Item ID: D350-748-203 Accept ***N900040100*** Setup Start ***NS1***
 Revision ID: Stop ***NS2***
 Item Name: AS350 / AS355 Stainless Steel Aft Crosstube
 Start Date: 4/10/2017 Start Qty: 1.00 ***1*** Cust Item ID:
 Required Date: 4/24/2017 Req'd Qty: 1.00 ***1*** Customer:
 Reference: SCHEDULED

DART AEROSPACE LTD		Work Order: 158990
Description: Crosstube High Aft, SS (AS350/355)		Part Number: D350-748-203
Inspection Dwg: D350-748-243 Rev: A		Page 1 of 1

DART AEROSPACE LTD HAWKESBURY, ONTARIO, CANADA	
DRAWING NO. D350-748-243	REV. A SHEET 1 OF 4
TITLE CROSSTUBE (AS 350/355 HI AFT)	SCALE NTS

DRAWING NO. D350-748-243	TITLE CROSSTUBE	REV. A	DART AEROSPACE LTD ENGINEERING ORDER		D.E.O. NO. D350-748-243-A-1	SHEET NO. SHEET 1 OF 1	SCALE NTS
DRAWN <i>qp</i>	CHECKED <i>ASS</i>	MFG. APPR. <i>[Signature]</i>	APPROVED <i>[Signature]</i>		DE APPR. <i>[Signature]</i>		
DATE 15.11.18	DATE 15.11.18	DATE 16.02.19	DATE FEB 19 2016		DATE 2016.02.19

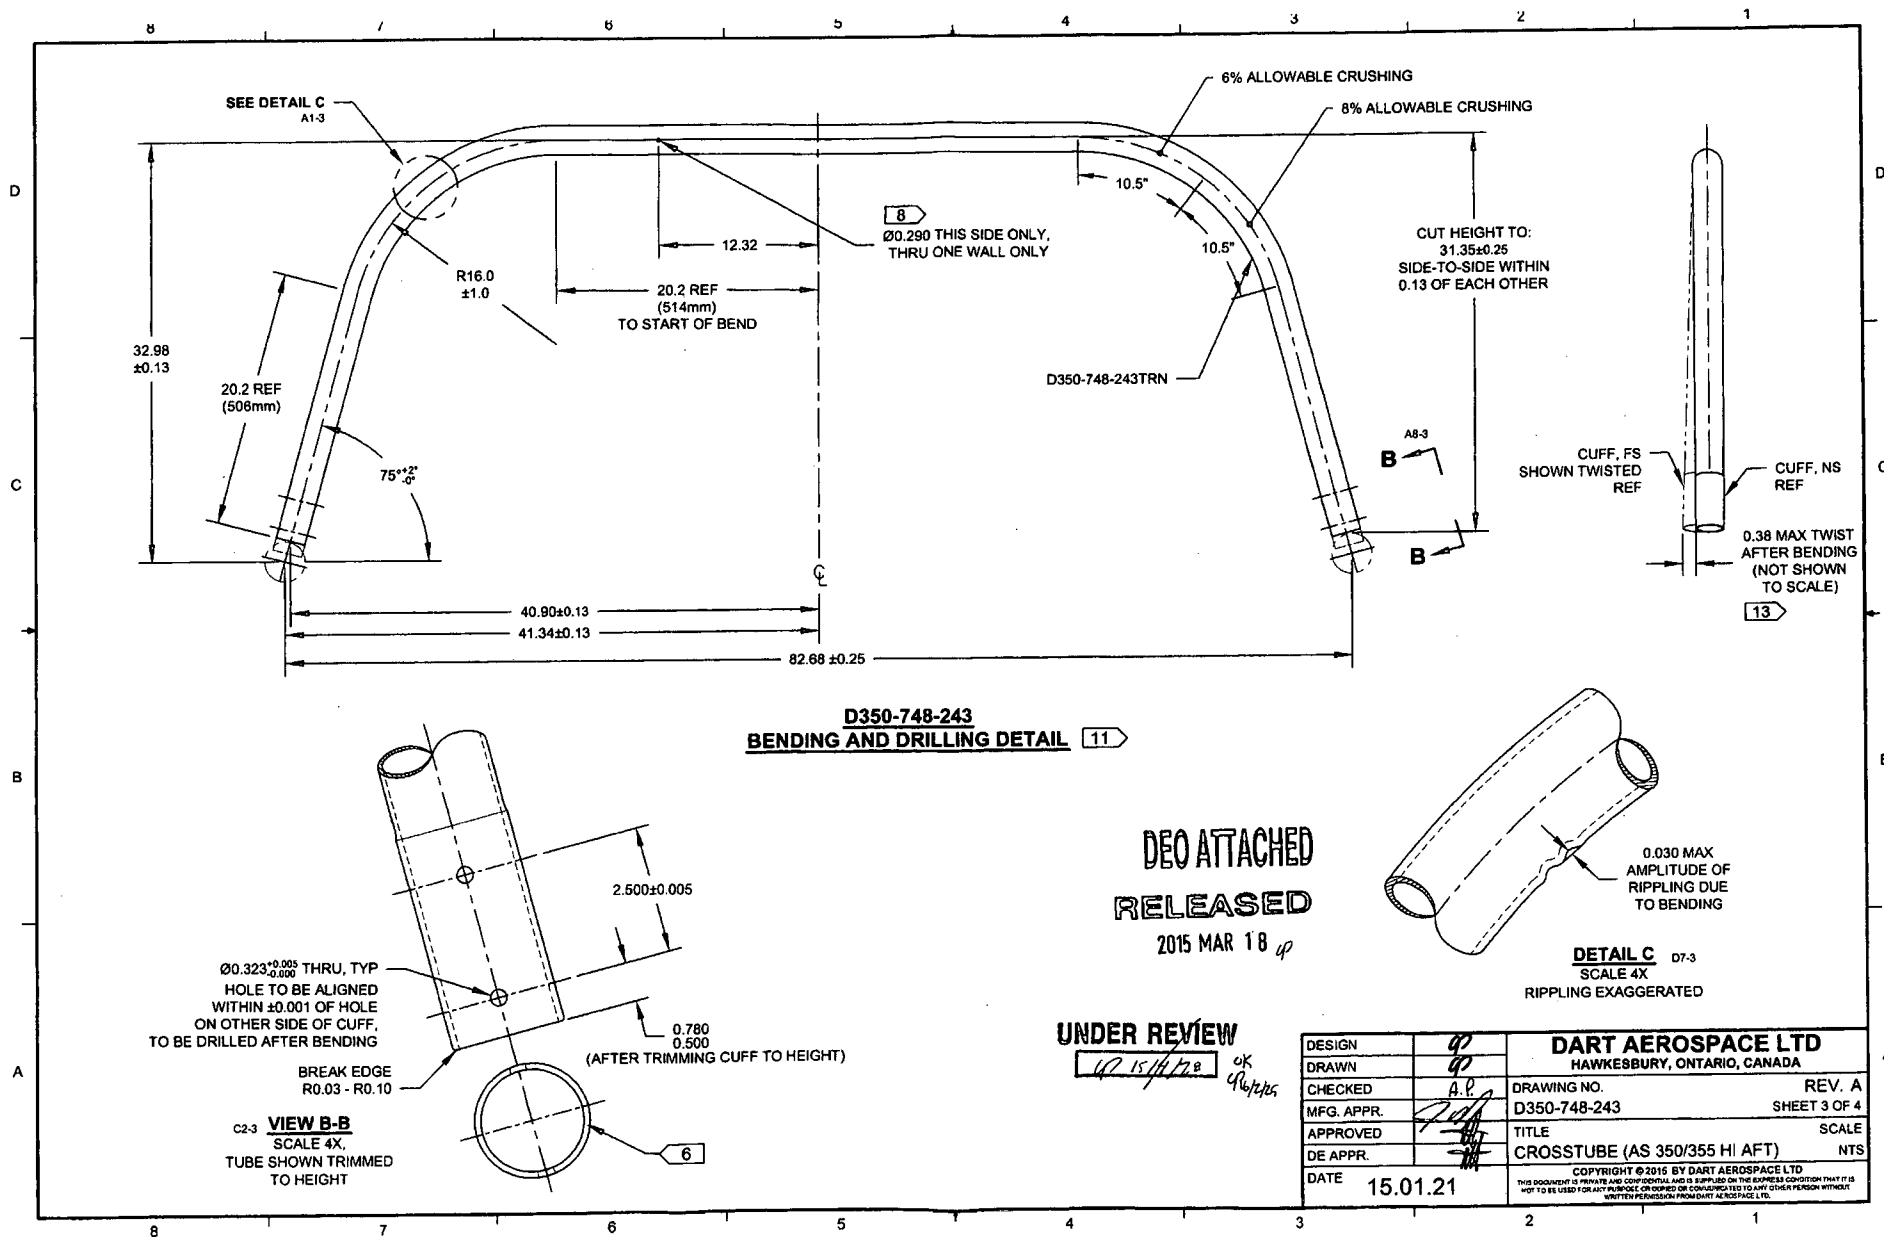
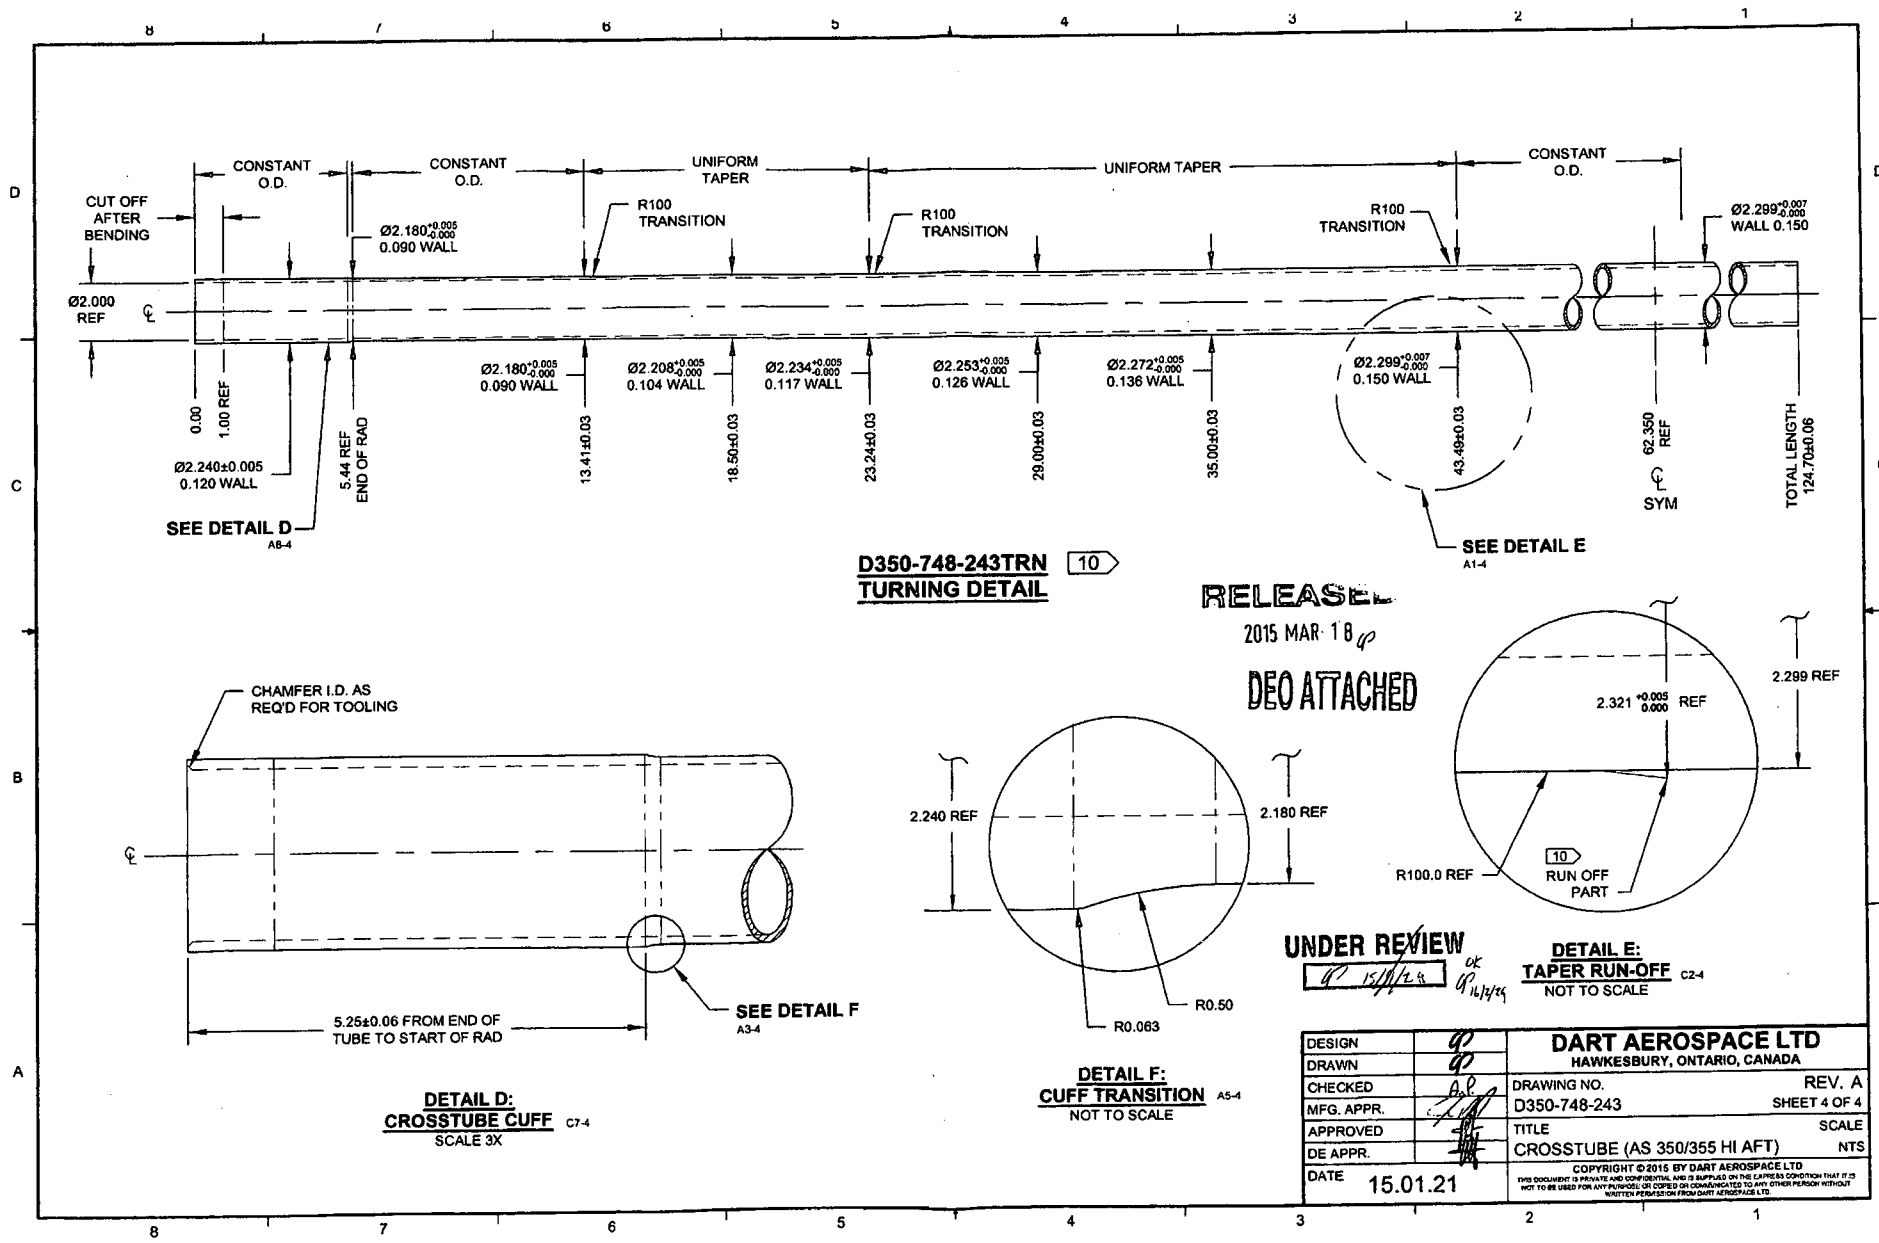
AMEND NOTE 2 (SHEET 1) AS FOLLOWS:

- 2) FINISH: PREPARE SURFACE PER DART QSI 005 4.1.4
 PRIME INSIDE AND OUTSIDE PER DART QSI 005 4.2
 PAINT OUTSIDE PER DART QSI 005 4.2
 OR
 POWDER COAT WHITE (4.3.5.2) PER DART QSI 005 4.3
